Application reference 2025/1489/P

Extension and refurbishment of the existing church building including an ancillary cafe and new level access from Finchley Road. Holy Trinity Church Finchley Road London NW3 5HT

Current roof directly adjoining Alban House

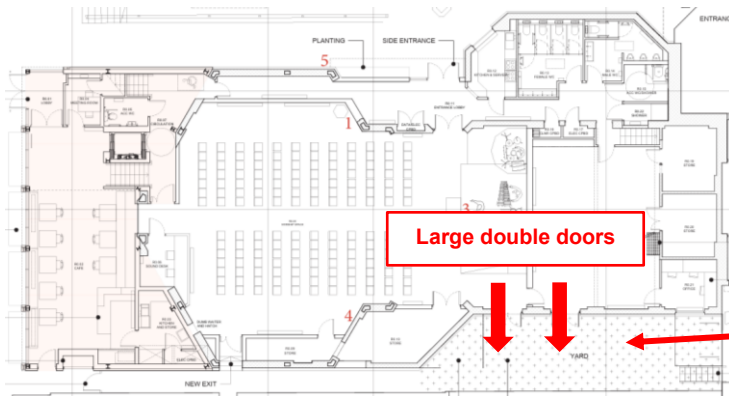
Of particular concern to Alban House is the potential noise breakout from the new rooflights above the main stage and worship space. As shown on the following photograph the existing roof is solid without any window openings.

However six new rooflights are proposed in the main roof and two further within the smaller section directly adjoining Alban House.

The plans do not provide sufficient detail to determine whether the rooflights would be openable or simply fixed panes. If openable clearly this has the real potential to result in noise impacts for Alban House. Even if the rooflights are to be fixed no detail has been provided in terms of the acoustic properties of the glazing. An assessment is required in this regard.

Ground floor plan

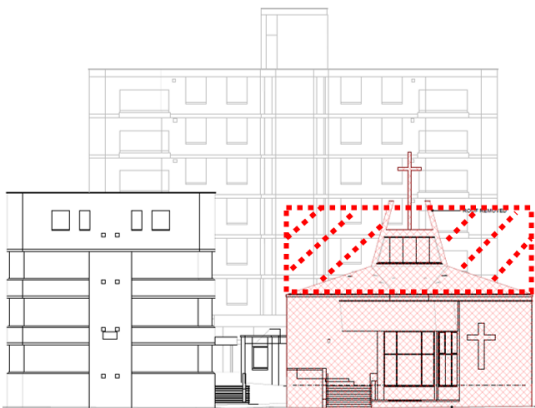
At present this space is largely unused but the proposed plans show two sets of double doors opening out onto this space. The area is within very close proximity of the front windows and balconies of the Alban House properties and the rear windows of The Quarters. If the doors are left open during services or performances this would result in significant noise concerns.

Similarly the use of this space as a breakout area where people may gather has the potential to cause noise and disturbance for the residents of Alban House and The Quarters. The application should clarify the applicants intent for this space so that the impacts can be considered as part of the application.

Finally the plans show a bell of reasonable scale located to the north side of the building. Its use is unclear. However by its nature subject to its proposed use / frequency of use it is likely to cause disturbance to Alban House residents. This matter is not addressed in the acoustic report or elsewhere in the application package. This matter should be clarified by the Applicant.

Existing elevation with additional massing added

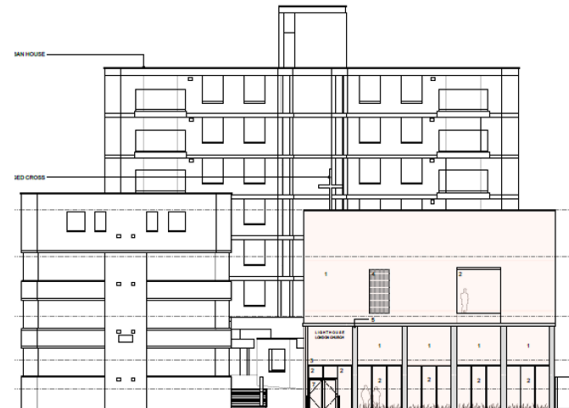
As shown below the proposed works will increase the apparent bulk and massing of the building in front of Alban House.

Proposed elevation view from Alban House

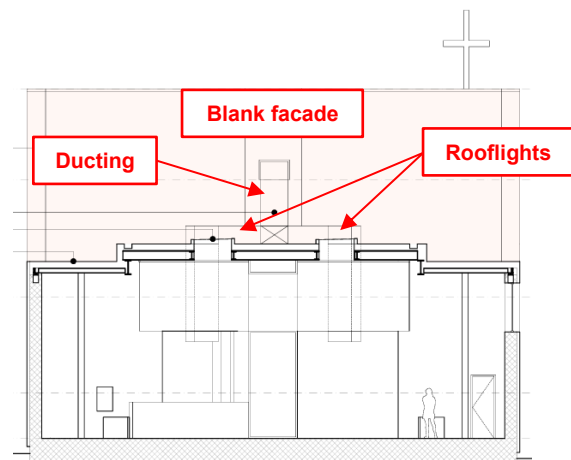
As shown opposite, the rear (east) elevation facing Alban House is proposed to be a blank rendered façade with plant ducting running down from the plant area onto the replacement flat roof.

The flat roof itself is proposed to be punctuated by rooflights as noted above in the context of the comments provided on noise issues.

In summary where residents currently look out past and around the conical shaped rood this outlook will be removed (particularly for those at 2nd and 3rd floor levels) and replaced with a full blank wall removing this sense of space.

View showing the green roof at The Quarters

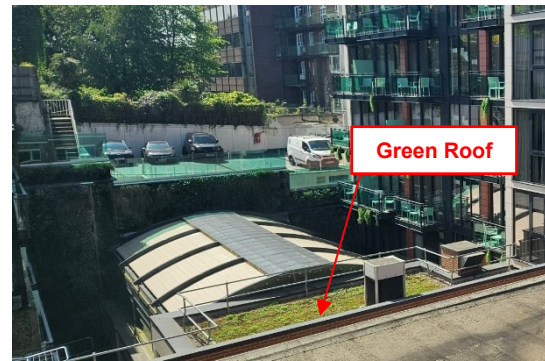
These harmful impacts could in part be mitigated through the provision of some greening in this area to soften the outlook and disguise the blank façade and ducting. A green roof, similar to that provided at the recent redevelopment of The Quarters (see opposite) would also assist in terms of mitigating the appearance and prominence of the rooflights. It would also assist in promoting biodiversity and addressing climate change.
